**RESPONSE TO PRE-BID QUERIES FOR SUPPLY AND INSTALLATION OF FRP FENCING FOR 11KV DISTRIBUTION SUB-STATION IN TP CENTRAL**  
**ODISHA DISTRIBUTION LIMITED AGAINST TENDER NUMBER- TPCODL/P&S/54/2020-21**

(Revised Drawing Number-1,  
Drawing Number- TPD-S-208-C-013 &  
Drawing-3)

**Drawing No-1 for FRP fencing**

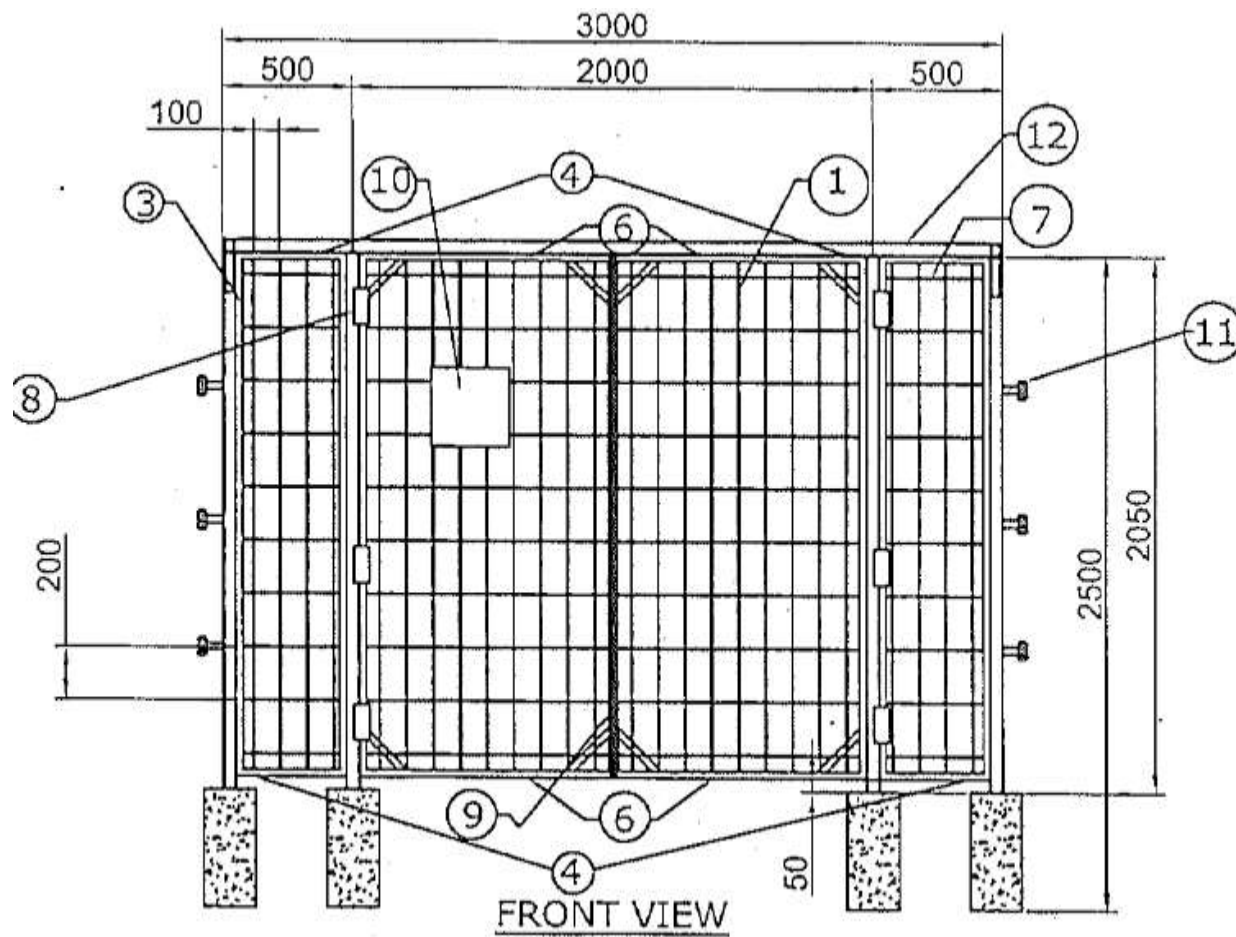
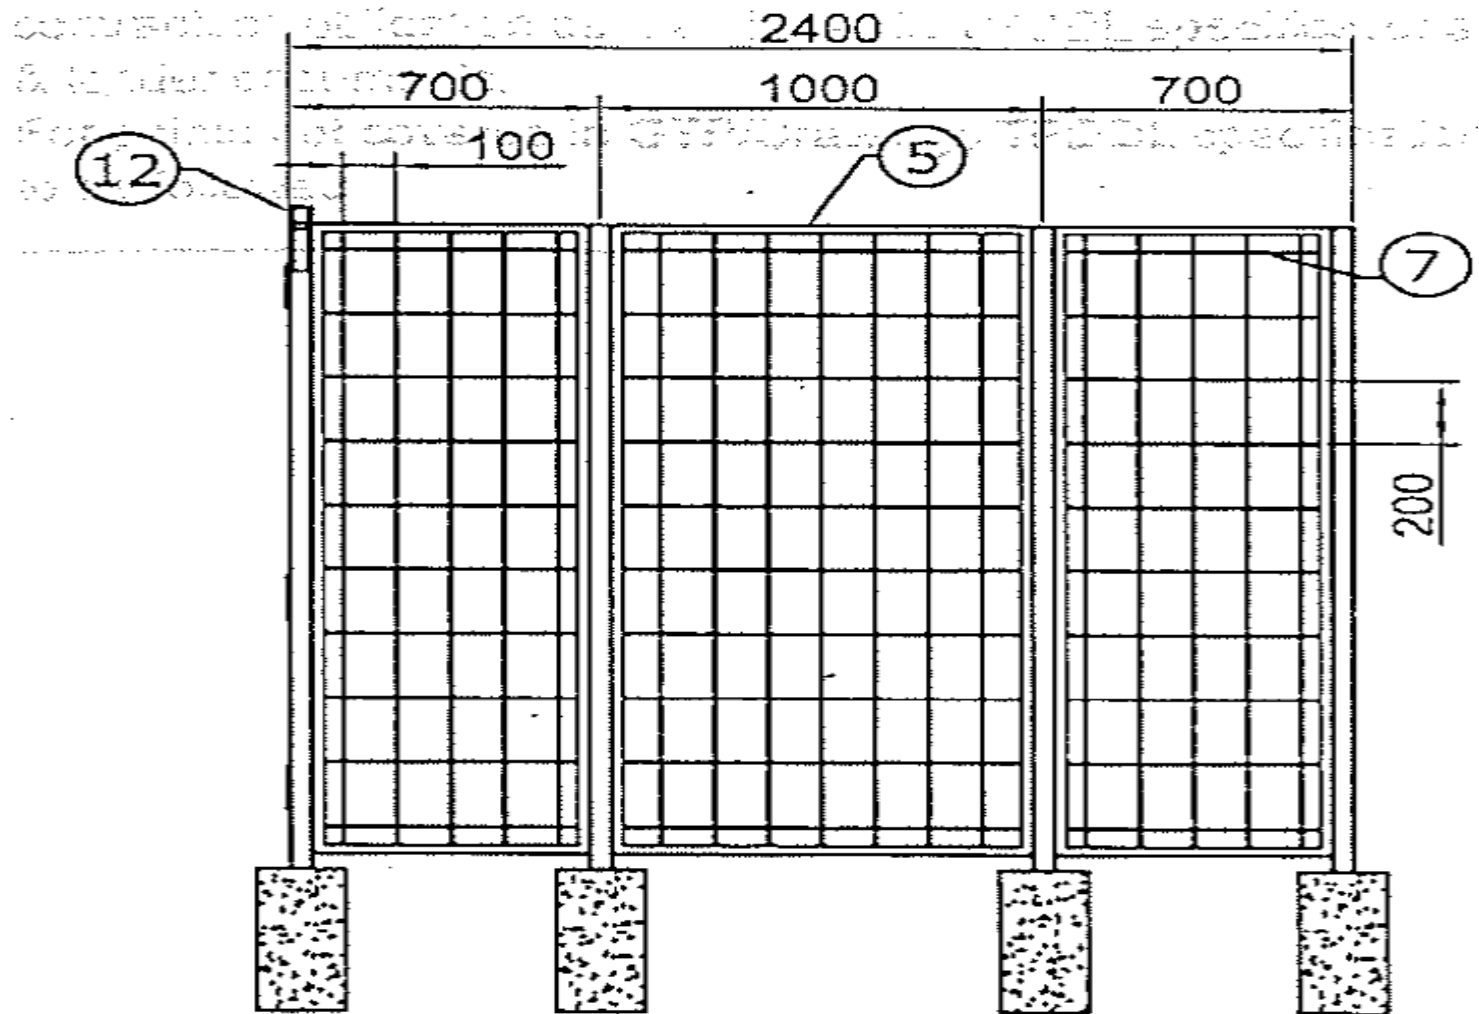
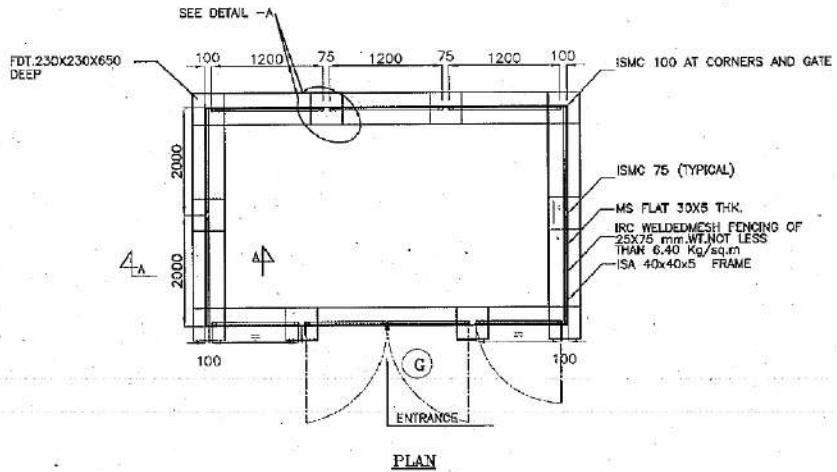
Sr. No.	Description as per Bid Document	Remarks - Query / Clarification	TPCODL RESPONSE
1	There is two no's drawing available in technical specification in page 49 & 50. Page no 49 drawing as per the FRP fencing specification.	However, page 50 drawing specification is not as per FRP fencing arrangement as it is showing GI chain link fencing with M.S Pipe, Barbed wire etc. Therefore please advise the correct drawing .	Revised drawing No. 1 for FRP, drawing No.TPD-S-208-C-013 for Civil foundation work where only civil work to be referred and Drawing 3 explaining customization required in FRP fencing is attached as Annexure to this response
2	Annexure-I ,Page no-14- It has mentioned FRP fencing as per specification	In the specified drawing, nowhere FRP has mentioned, Please advise accordingly	Fencing has to be of FRP as per specification requirements.
3	There is two no's drawing available in technical specification in page 49 & 50. Page no 49 drawing as per the FRP fencing specification.	However, page 50 drawing specification is not as per FRP fencing arrangement as it is showing GI chain link fencing with M.S Pipe, Barbed wire etc. Therefore please advise the correct drawing .	Refer response to Sl. No.1

4	Annexure-I ,Page no-14- It has mentioned FRP fencing as per specification	In the specified drawing, nowhere FRP has mentioned, Please advise accordingly	Refer response to Sl. No.2
5	Pg. 47 and 48 of Tender Document- We are considering the specification of FRP fencing kit as per enclosed dimension (1a & 1b)	Please advise the specification if any Accordingly the Rate can be considered.	Fencing overall dimensions shall be as per specification and the components list we have submitted are the minimum components to be provided in fencing. Further the components can be more as per manufacturer design to meet the required strength of fencing. The bidder has to show the demo fencing during presentation at the time of technical evaluation. The material should meet the specification requirements. ( Refer Revised drawing No. 1 for FRP, drawing No.TPD-S-208-C-013 for Civil foundation work where only civil work to be referred and Drawing 3 explaining customization required in FRP fencing is attached as Annexure to this response)

No.	Item	Profile	Dimension	Qty.
1	Pickets/vertical flats	Flats	40 x 5mm Thk	101
2	vertical posts	SQ Pipe	50.8 x 50.8 x 3.175 mm	12
3	vertical pipe(frame)	Rect.Pipe	50.8 x 25.4 x 3.175 mm	26
4	Horizontal pipe(frame)	Rect. pipe	50.8 x 25.4 x 3.175 mm	16
5	Horizontal pipe(frame)	Rect.Pipe	50.4 x 25.4 x 3.175 mm	6
6	Horizontal pipe(gate frame)	Rect. pipe	50.8 x 25.4 x 3.175 mm	4
7	Rail	Notch & groove bar	Ø12 mm	111
8	Hinges		S.S material	6
9	Door Stopper (Vertical)		F.R.P	1
10	Danger Board		M.S. Material	1
11	Nut bolt & washer	M12 x 100	S.S. Material	30
12	Horizontal pipe(frame support)	SQ. Pipe	50.8 x 50.8 x 3.175 mm	1
13	Door Stopper (Horizontal)	Rect. Pipe	50.8 x 25.4 x 3.175 mm	1
14	Stud Bolt	M12X120	S.S. Material	18
15	Bolt	M6 X 100	S.S. Material	2

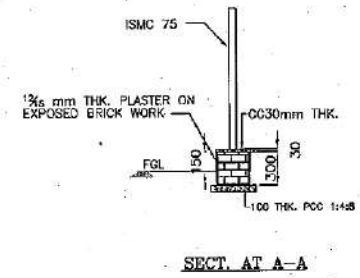
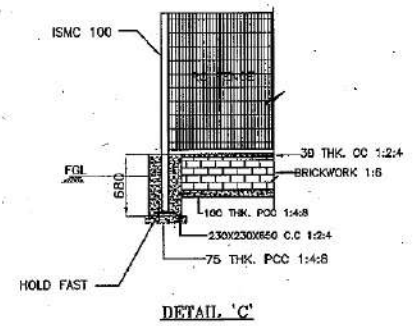
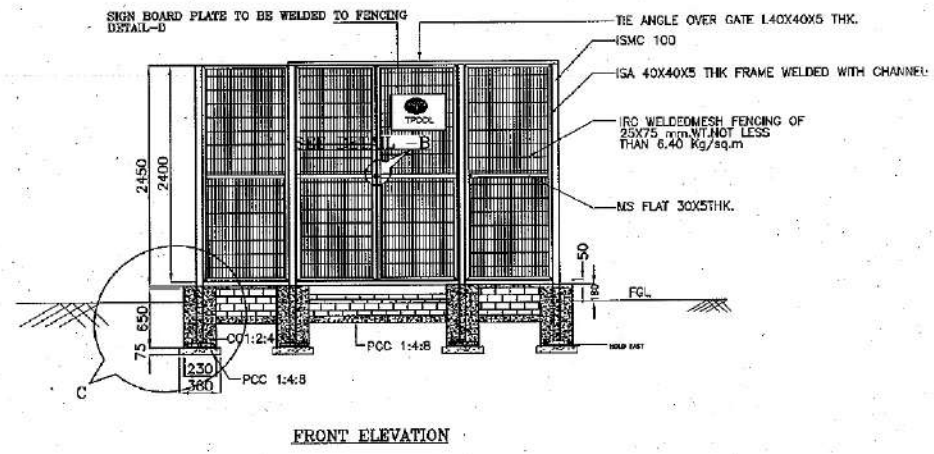
Sr. No.	Description as per Bid Document	Remarks - Query / Clarification	TPCODL RESPONSE
21	Technical Specifications	Bolts- MS or SS ? We are considering SS. Please confirm	Bolt material shall be SS only along with washers.
22	Annexure-1 BoQ. Page 14 of 39	1. For Qty (Page 14 of 39) : should all location have standard dimensions? 2. Unit for item 1 and 2 are reversely mentioned	1. No. Dimension at all location will vary, it is not standard. a) Door Size will be standard as per drawing i.e. 1mtr X 2.05 Mtr. (Length-1 Mtr, Height 2.05 Mtr) b) Standard Panel size will be (1mtr X 2.05 Mtr (Length-1Mtr, Height 2.05 Mtr) c) Customized panel size will be based on the layout drawing of location of Distribution Transformer(DT). d) To complete the fencing of DT, number of standard panel and number of customized panel depends on size of fencing required which will vary from Location to Location. (Refer Drawing-3 attached as annexure to this document) 2. Units in annexure 1 in bid document is correct.

If Site location is like shown in graph, the no of FRP fencing panel an pit for fencing leg will be as given below.

1. If length of Fencing(AB & CD Branch) is 4.25 mtr and breadth of fencing(AD&BC branch) is 3.75 mtr. Then 4 No standard fencing pannel of 1mtr length and 2.05 mtr height & one pannel of .25mtr length and 2.05 height will be used for AB branch and seperate 4 No standard fencing pannel of 1mtr length and 2.05 mtr height & one pannel of .25mtr length and 2.05 heigh will be used for CD branch.

2. Similarly for branch of BC&AD,3 No standard fencing panel of 1 mtr length and 2.05 mtr height & one number of 0.75 mtr length & 2.05 mtr will be used for each branch(BC & AD).

3.Foundation will be done on at every four corner , every span of one meter and csutomised length as per site . Example is showhn bellwo

A,B,C,D and E are the location of Pit for FRP Fencing Legs
